Certified Action of the City of Raleigh Planning Commission

Case File / Name: SP-35-11 / Carolina Ale House – Glenwood South

SP-35-11 Carolina Ale House – Glenwood South – Preliminary Site Plan

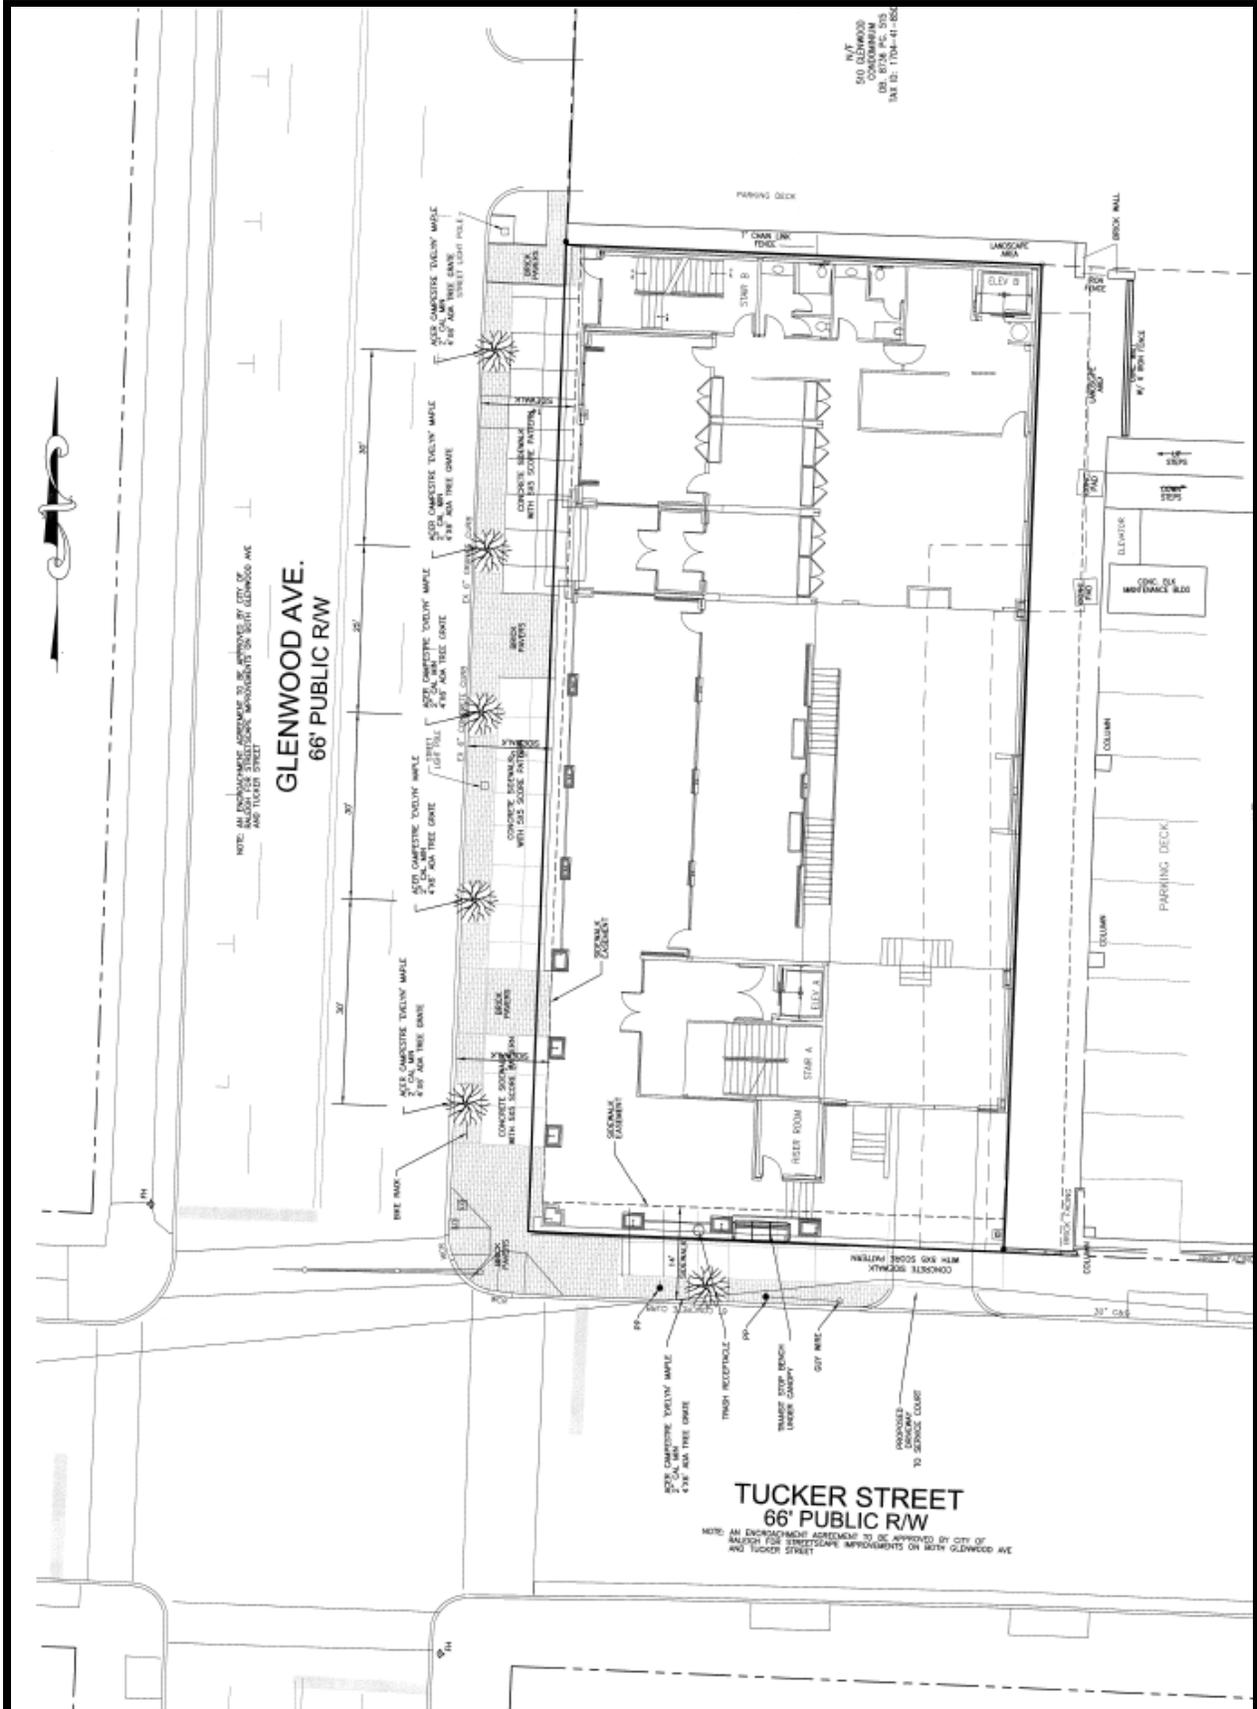
Key Issues: The 14' sidewalk requirement associated with the Pedestrian Business Overlay District is not being fully met along portions of both Glenwood Ave. and Tucker St. The applicants are requesting an alternate to this requirement.

VARIANCES / ALTERNATES: The applicants are requesting the Planning Commission approve an alternate to the required open space called for in the Pedestrian Business Overlay District which specifies all public sidewalks be a minimum 14' in width. The applicants are requesting an alternate to reduce the minimum width down to 12.5' for a span of 60' where an existing retaining wall is proposed to remain.

While the proposed project increases sidewalk width by extending the sidewalk from back of curb to building face for a minimum width of 14' for a portion of the site, there is a 60' span where the sidewalk width is interrupted by a retaining

wall and reduced down to only 12.5'. Staff recommends that the project be designed such that the retaining wall can be used to provide a seating amenity to patrons of the Pedestrian Business Overlay District.

PEDESTRIAN: A 14' wide sidewalk is required along the property's frontage on Glenwood Avenue and Tucker Street and is being provided by the applicants along much of the site with the exception of a 60' span of Glenwood Avenue where an existing retaining wall is proposed to remain and proposed steps encroach in the area. (This reduces the sidewalk width down to 12.5' in width on that section of Glenwood Avenue.) and with the exception along a 44' portion of Tucker Street

where a transit amenity and a transition down to the neighboring sidewalk width is being provided that reduces the sidewalk width down to 9'-10' in width. The reduction in sidewalk width is authorized by section 10-2155(d)(4) , last paragraph ,provided the Planning Commission finds that the reduction is in accordance with the general plans for the physical development of the City as embodied in the Comprehensive Plan and the Commission finds that the site plan complies with section 10-2132,3 subsections (c) and (d). Planning Staff opposes the introduction of steps into the 14' wide sidewalk and recommends that the plan be revised such that the stairs are moved internal to the face of the proposed building.

- (1) That the Planning Commission finds that this site plan meets the standards for approval of a preliminary site plan, Code Section 10-2132.2(d);
- (2) That in accordance with Code Section 10-2055(d) (4), last paragraph, the Planning Commission approves a reduction to the 14' wide sidewalk along portions of Glenwood Avenue for the existing retaining wall to remain and portions of Tucker Street to allow for a transit amenity and a transition to neighboring sidewalk widths;
- (3) That the plan be revised to move the proposed steps internal to the building footprint facing Glenwood Avenue such that they do not project beyond the face of the building, thereby allowing the 14' sidewalk section to be met in that approximately 15' wide section;
